Value Engineering

Final Report

Grand Valley Irrigation Company Fish Screens

February 28, 2000

Figure 6. Overview Plan Proposal No. 1A.

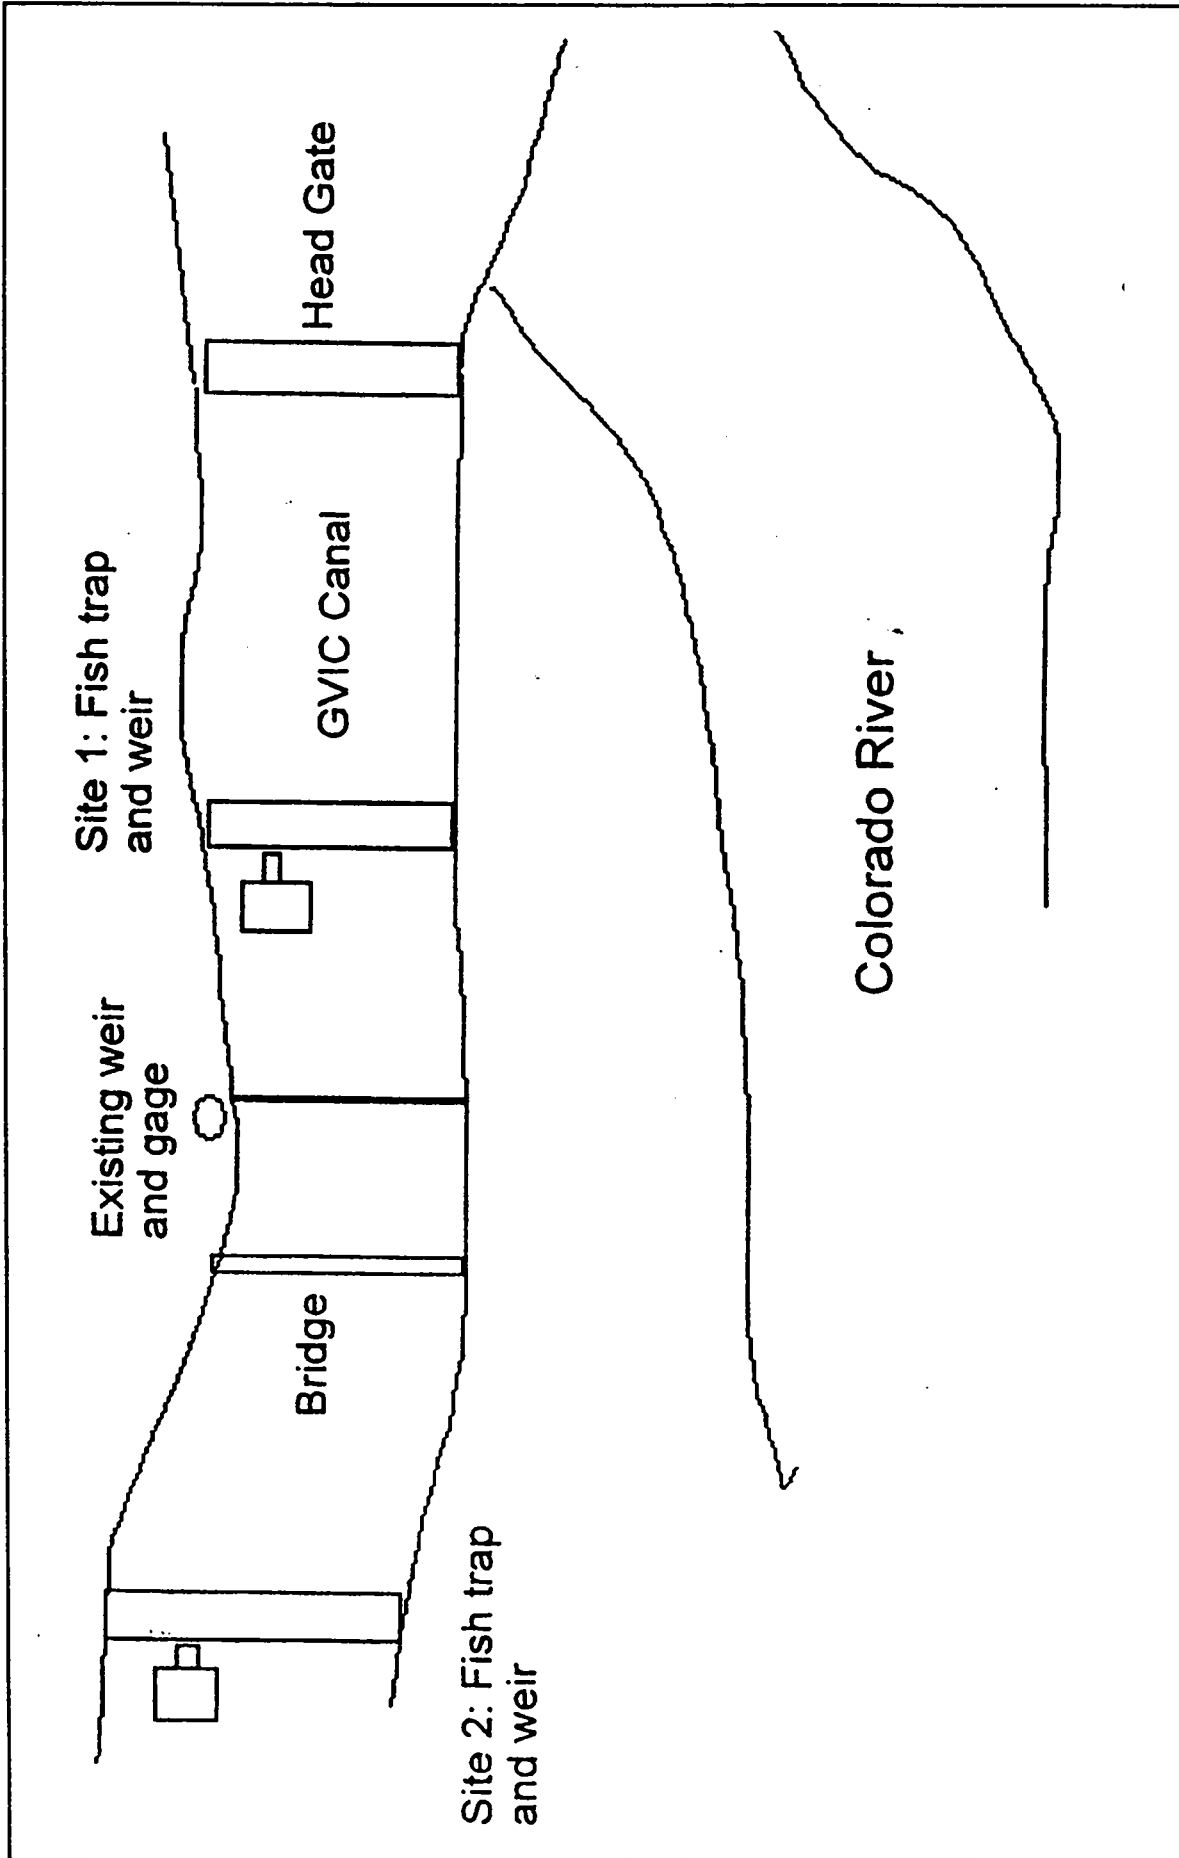
The first screening structure is planned to be constructed in or just upstream of the Grand Valley Irrigation Company Canal (Figure 6). The GVIC wants to work cooperatively with the U.S. Fish and Wildlife Service to protect Colorado pikeminnows and Razorback suckers, but they also must continue to maintain the water supply to their water users. Although U.S. Fish and Wildlife Service biologists argue that it is only a matter of time before endangered fish enter the GVIC canal, water users believe there is not enough evidence to date to justify or support the costly construction of the fish screen structure in the canal. The question is whether to move ahead with the current project based on the limited information or to spend additional time now to collect fish movement data to insure a better design and project success. The Value Engineering Team proposes that additional studies be conducted to collect this information.

- **Ways to Implement:** A study is needed to determine endangered fish movement into the GVIC canal. This can be accomplished by building a small nonpermanent fish weir and trap in the canal downstream of the headgate. Fish can be collected throughout the water delivery season (April-November). This data would then be used to confirm the presence or absence of fish, fish movement patterns, and fish species type, size, and age. In addition, this data could also be used to explore the possibility of using a weir to capture and remove endangered fish from the canal and returning them to the river instead of using a more permanent fish screening structure. Sampling may need to occur during the day and at night, and during different flows and operations times of the head gates. It will cost approximately \$150,000 for the study; \$50,000 for the weir and \$100,000 for two biologists, equipment, and travel expenses to sample the canal for one season.

Figure 7. Overview Plan Proposal No. 2.

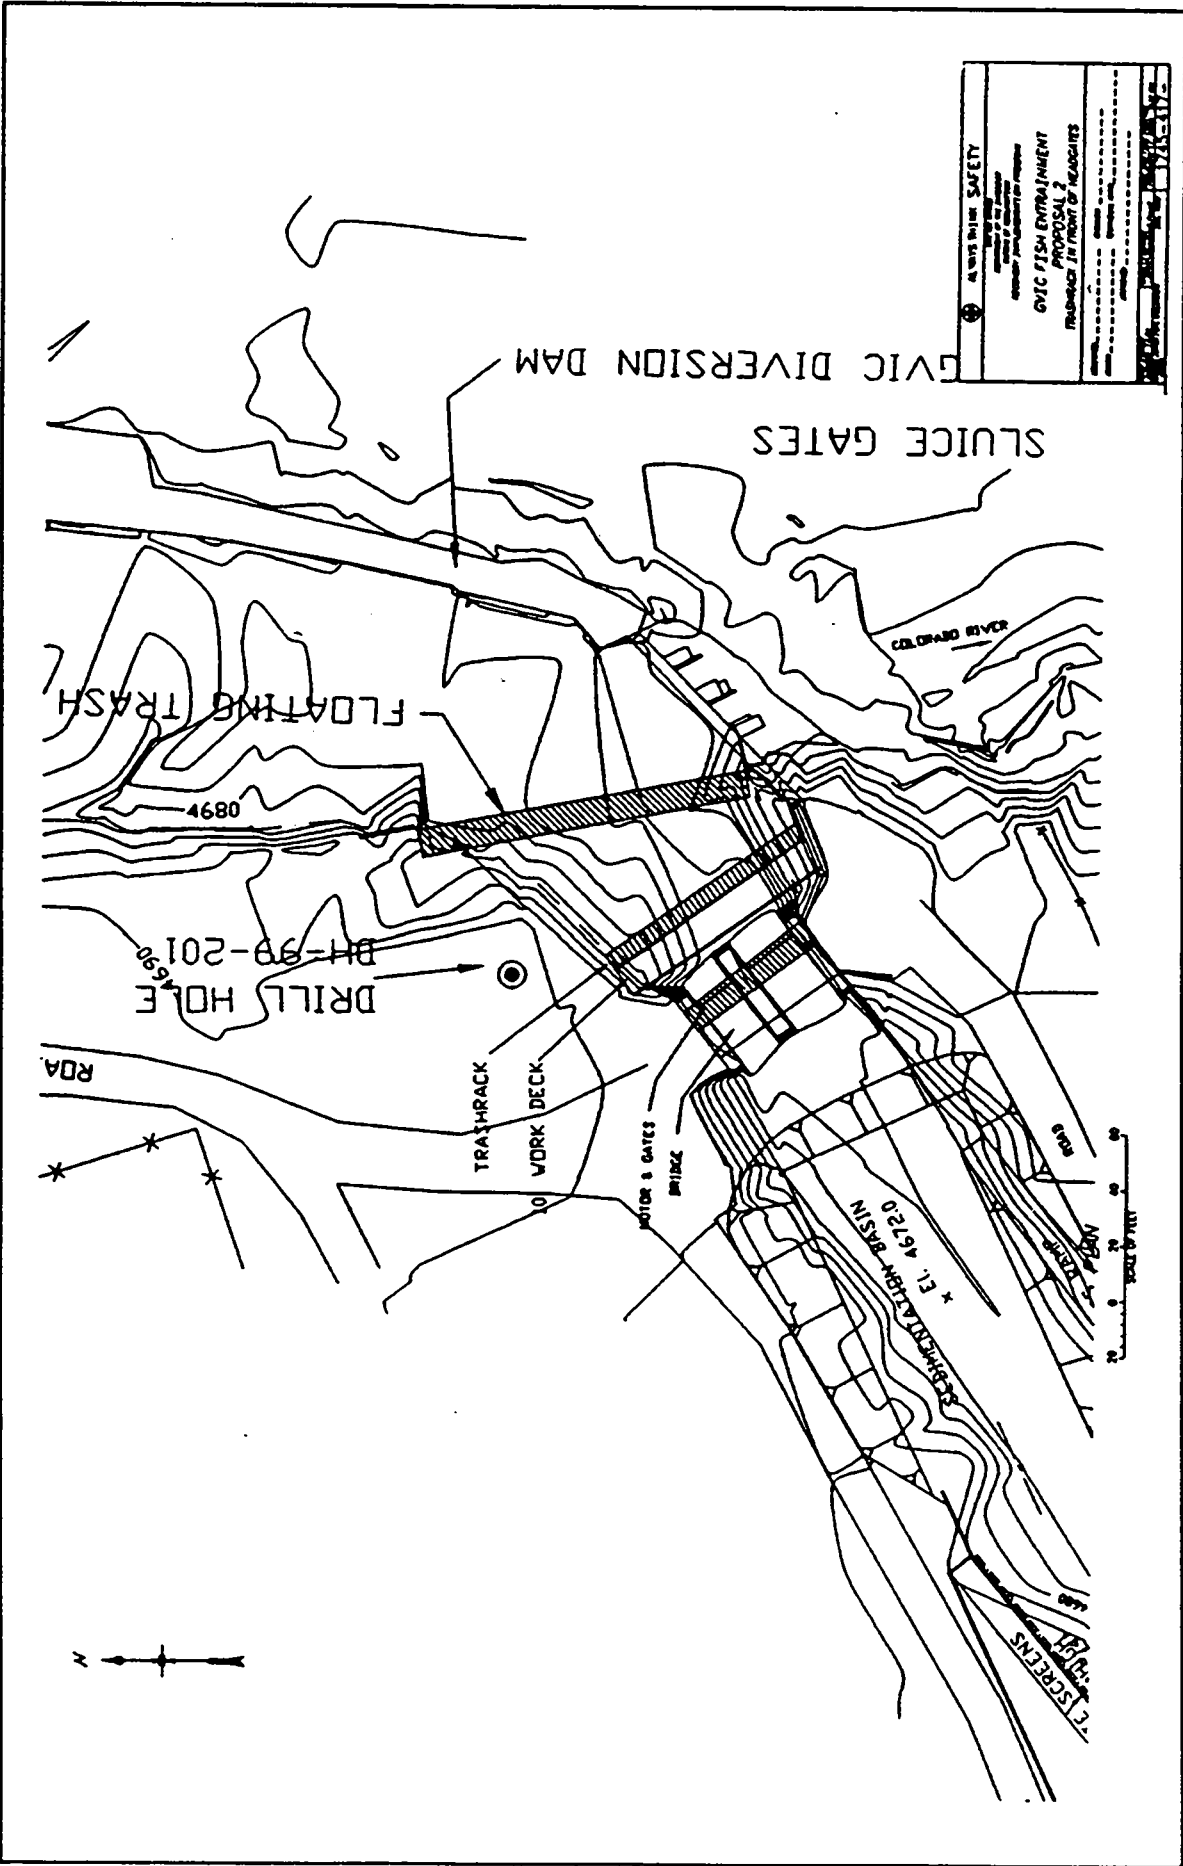
- Proposal Description: Install the trashrack in front of the headgates as shown on Figure 7.
- Critical Items to Consider: 1) In river construction requiring 404 permitting, 2) construction around existing headgates, and 3) cooperate with GVIC to allow alterations to be made to the headgates at the same time. This may permit an adjustment to the location of the sedimentation basin.
- Ways to Implement: Construct cofferdam and install during low water (winter).
- Changes from the Baseline Concept: Remove the proposed trashrack in the canal from the baseline (Option A) and move it in front of the headgates.

- Head loss through the trashrack.
- Possible changes in canal operation.
- Possible changes in flow patterns.
- Possible siltation in front of the headgates.
- Possible added congestion around existing headworks.
- Trashrack may impact headgate operations.

Figure 8. Overview Plan Proposal No. 3.

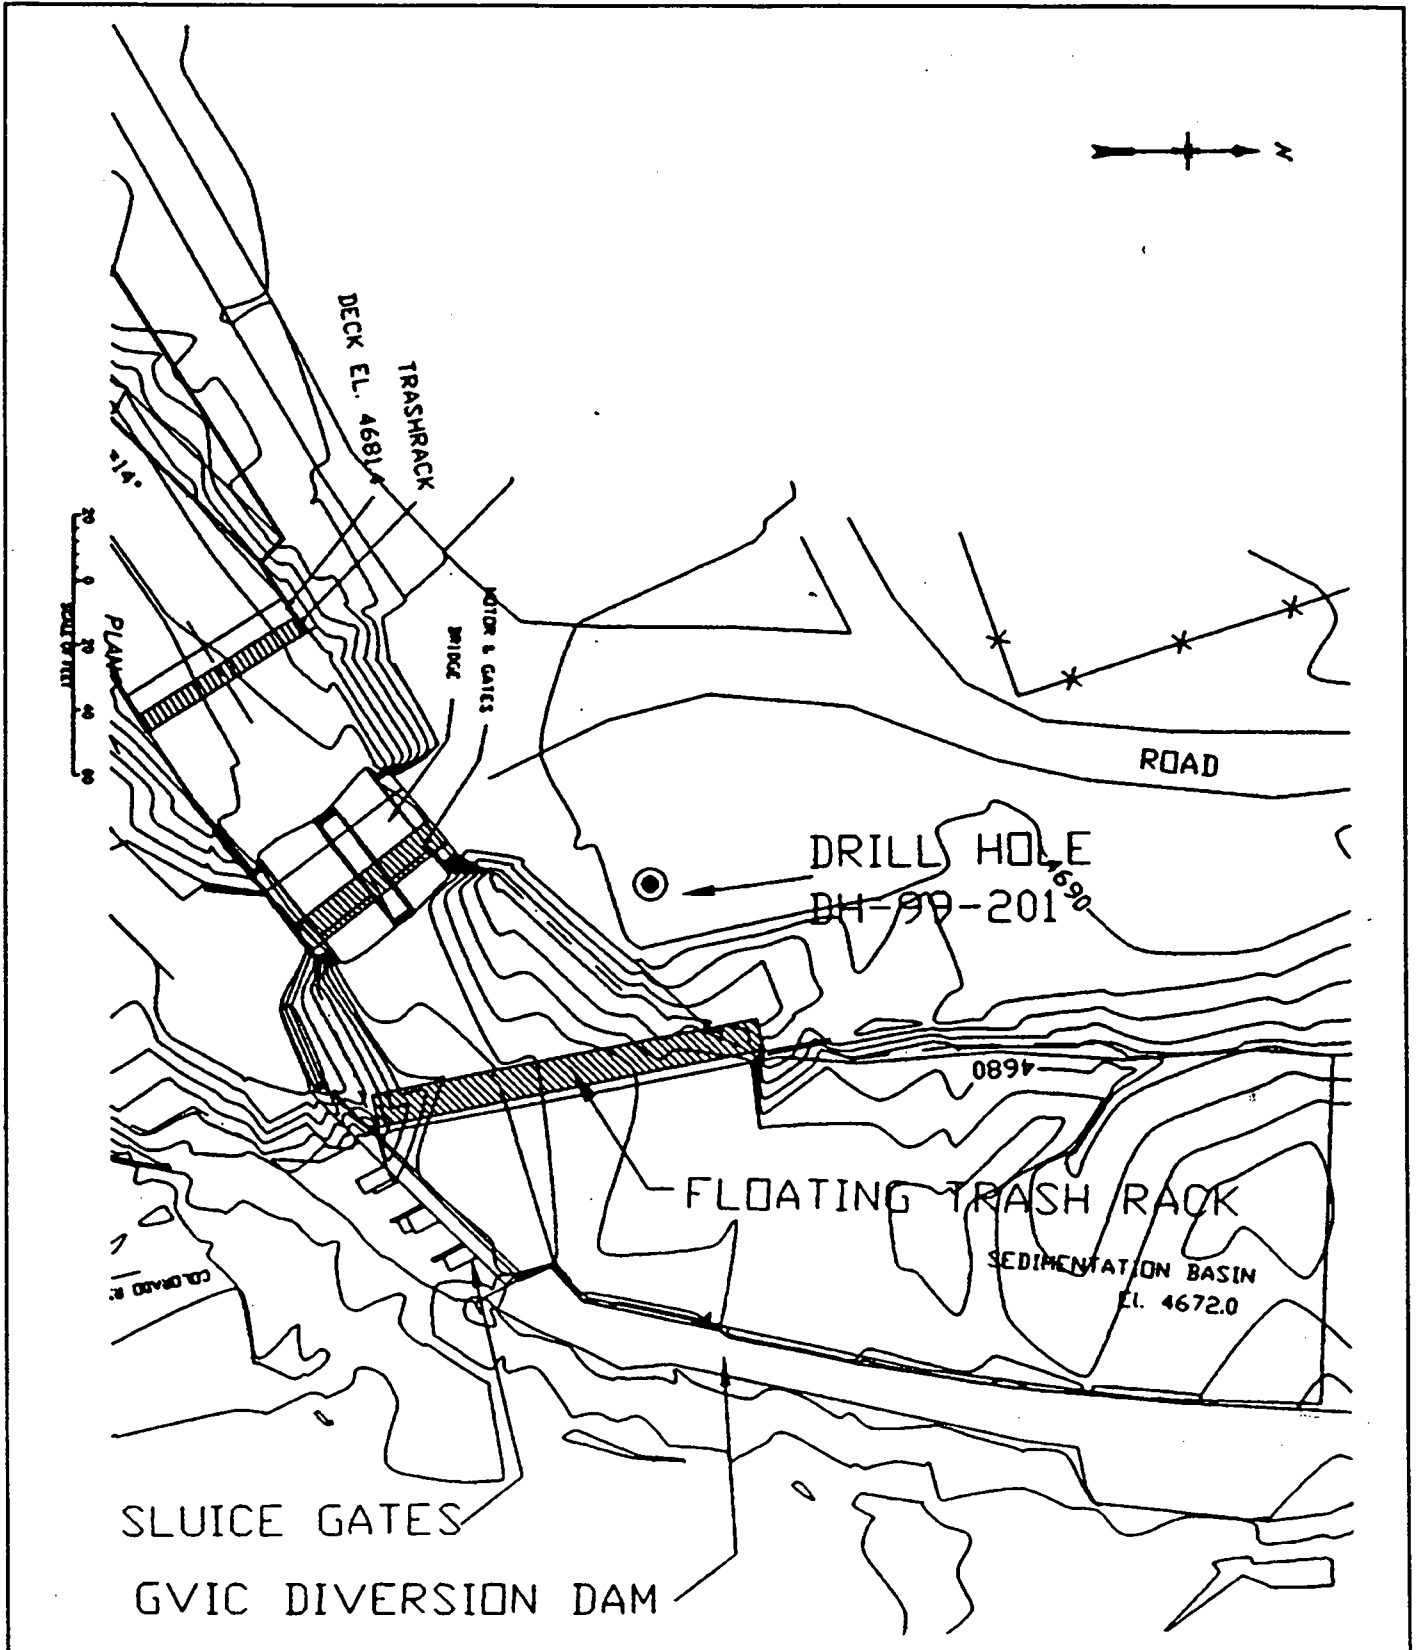
- Proposal Description: Build a sedimentation basin upstream of the diversion dam with sluicing capabilities, as shown in Figure 8.
- Critical Items to Consider: 1) In river construction with 404 permitting required, 2) cofferdam at low water construction (Winter construction), 3) if the flow capacity and drop of the floodgates was increased, this would improve the sluicing of the proposed basin, and. 4) some sediment would probably still have to be removed from in front of the fish screen.
- Ways to Implement: Cofferdam and divert river upstream, excavate basin.
- Changes from the Baseline Concept: Moves sedimentation basin out of the canal. Shortens footprint of the baseline (Option A) structure.

Figure 10. Overview Plan Proposal No. 5.

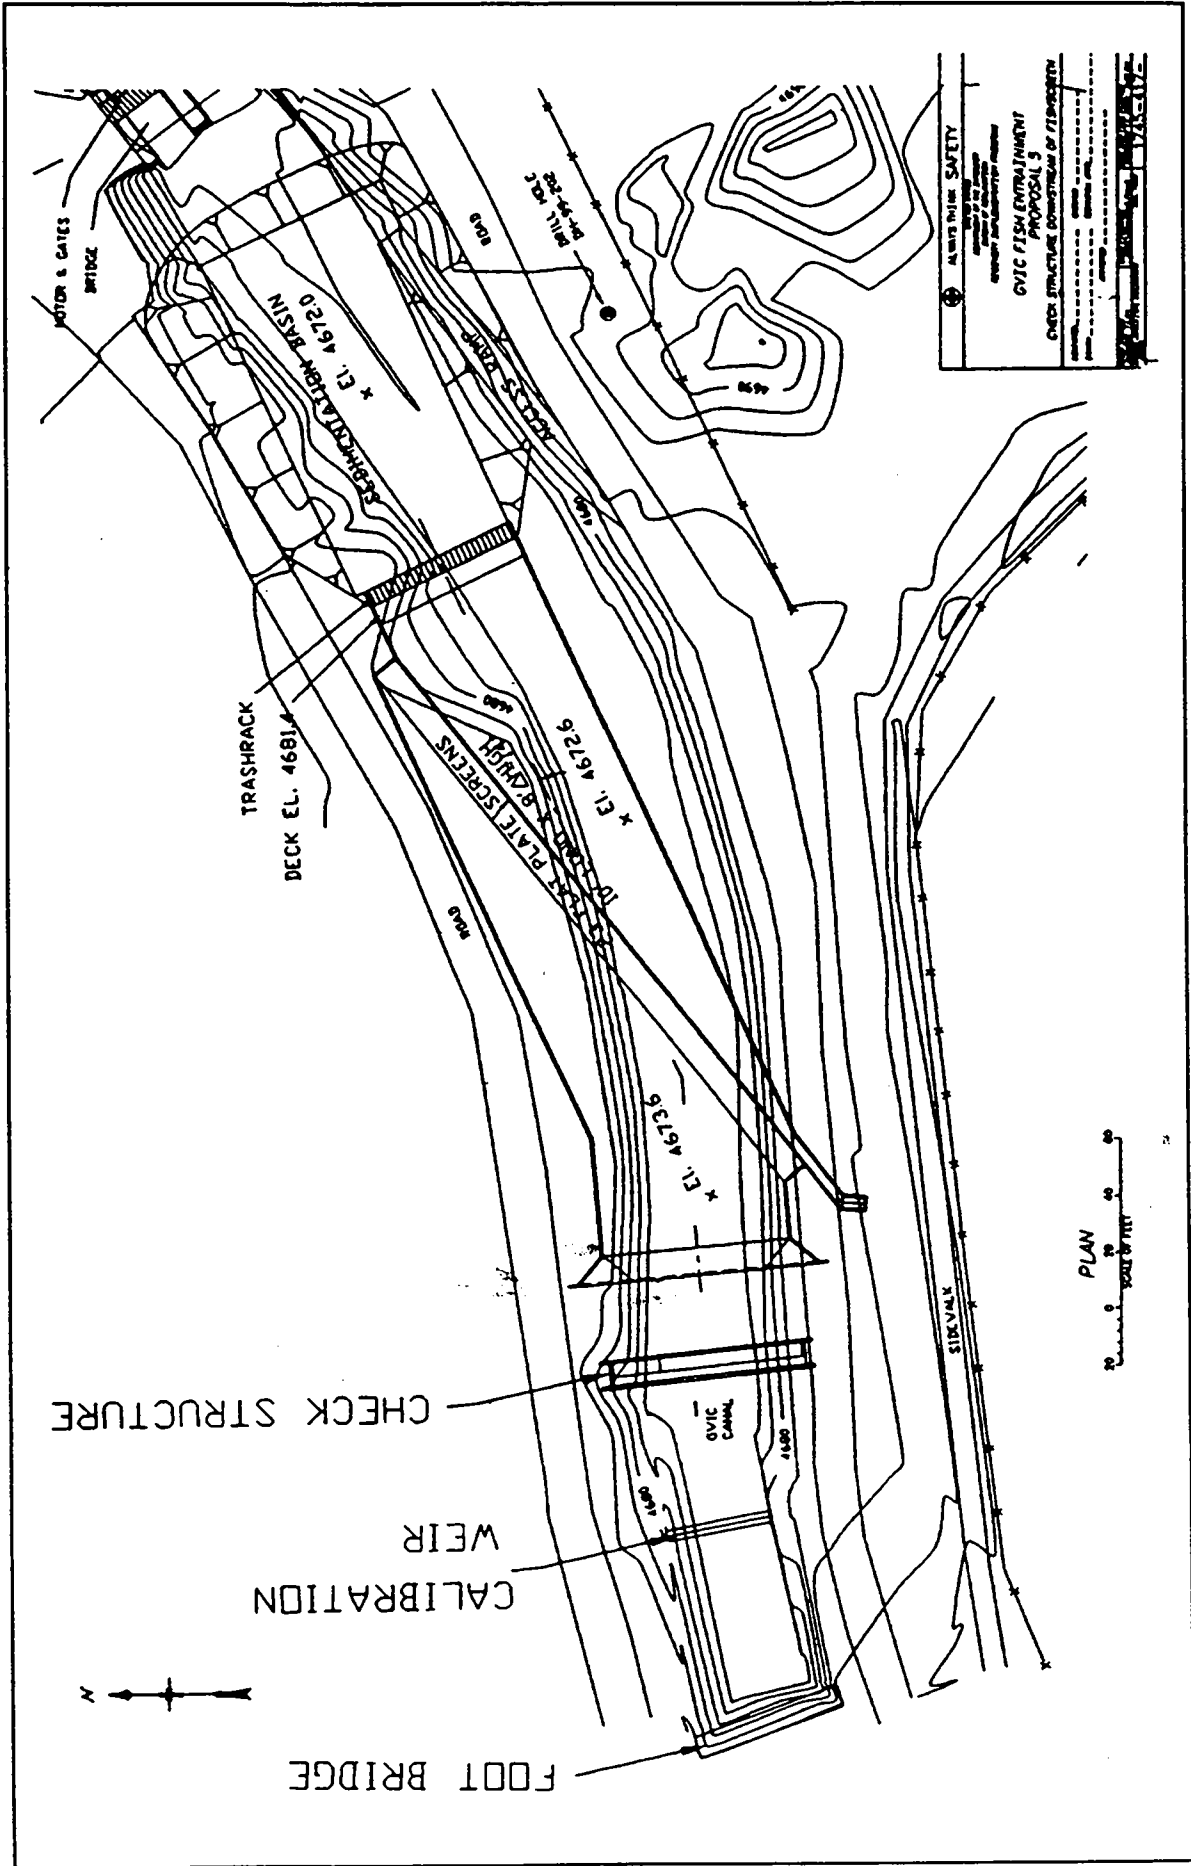
- Proposal Description: Install a stoplog check structure to check head to allow the baseline fish by-pass to operate at high river flows (approximately 20,000 cfs). See Figure 10.
- Critical Items to Consider: Effects on GVIC canal operations.
- Ways to Implement: Construct check structure just downstream of baseline structure in the canal during winter shut down.
- Changes from the Baseline Concept: Adds another structure to the baseline concept.
